ADDENDUM #1
REQUEST FOR BIDS
No. 2016-013

Project: Vehicle Bay Drains Repairs

This Addendum is incorporated into and made part of Request for Bids 2016-013, dated November 4, 2015. The purpose of this Addendum is to incorporate two drawings, which are described below and attached hereto, into Exhibit A (Drawings and Specifications) of the Solicitation. These drawings were inadvertently not included in the Solicitation when it was published.

NEW WORK STRUCTURAL PLAN

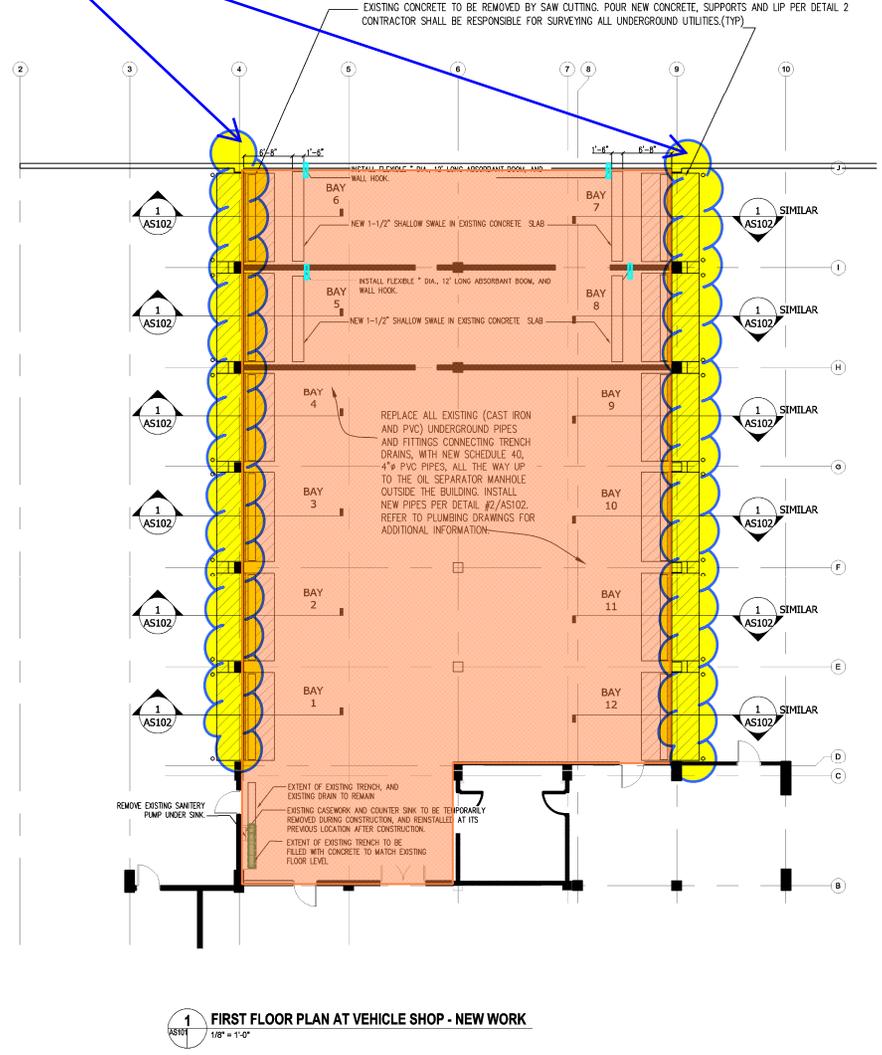
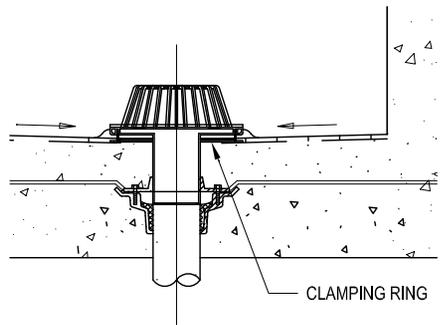
Slab cut demo work will be limited to just what's required for replacing CI pipes with new new PVC pipes, and replacing the drains. Please see P 101 markups.

The concrete work as shown in the detail above will not take place in the existing trench bays. Limited concrete work will take place to replace the existing drain and connect it to new PVC pipes as shown in the detail below.

Revisions
Drawing Title
PLUMBING DEMOLITION AND NEW WORK PLAN

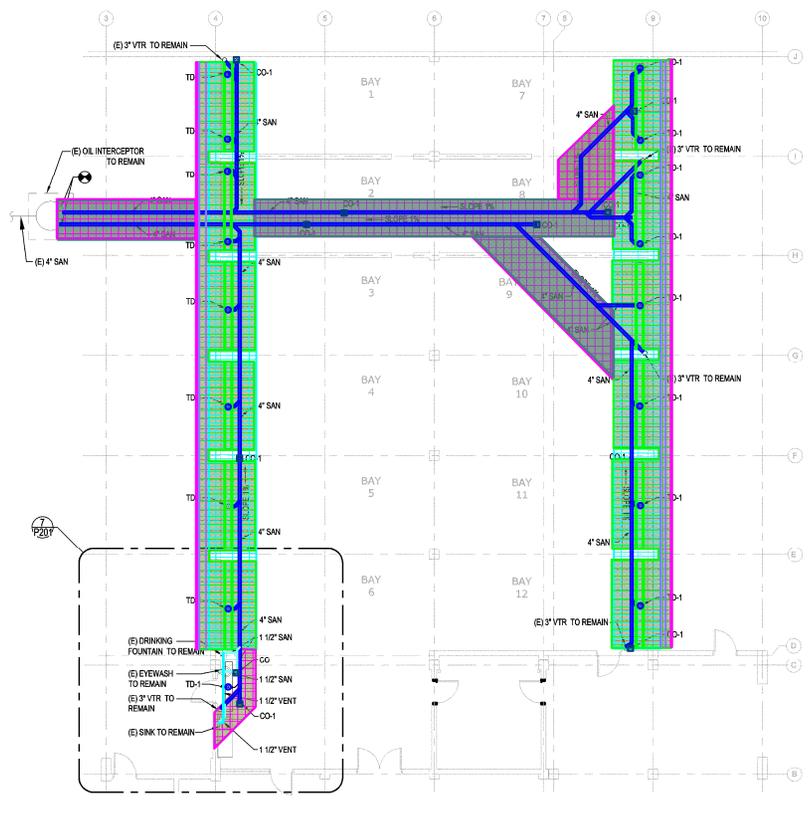
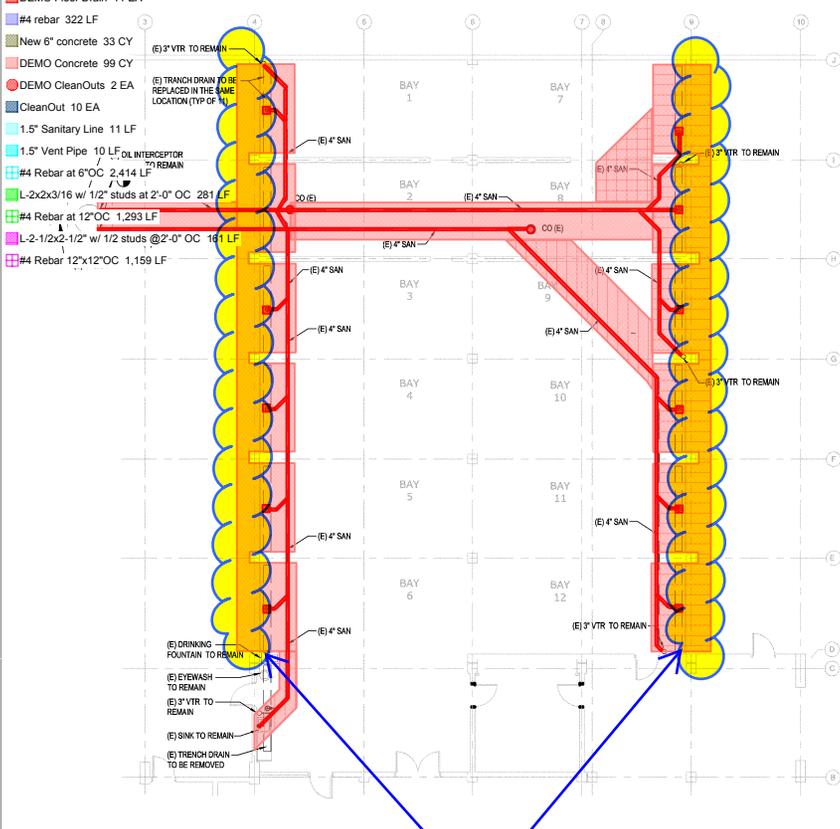
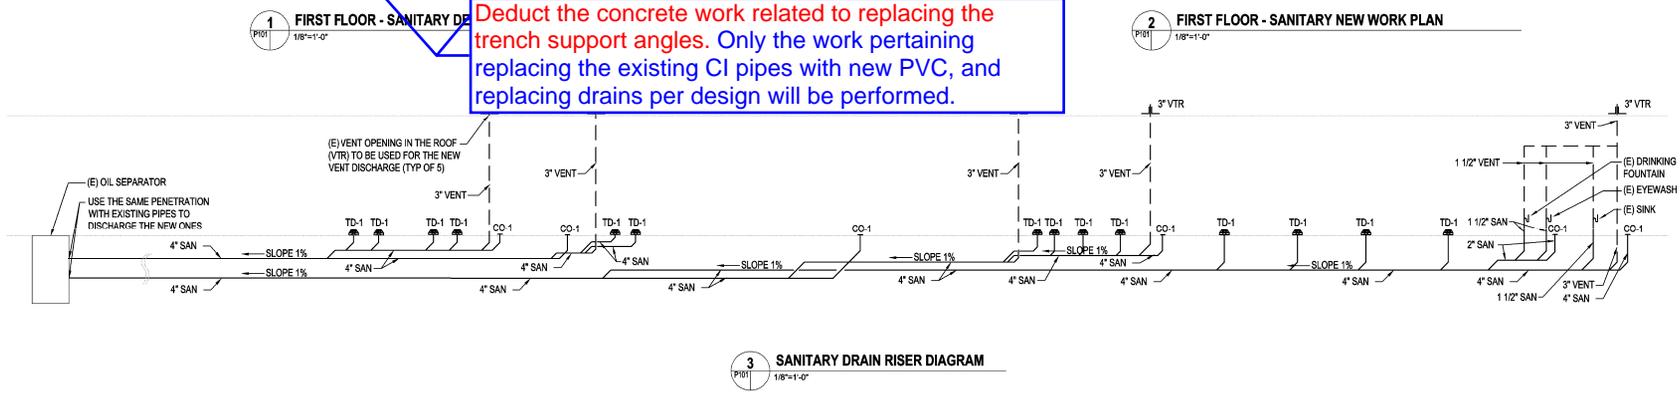
Deduct the concrete work related to replacing the trench support angles. Only the work pertaining replacing the existing CI pipes with new PVC, and replacing drains per design will be performed.
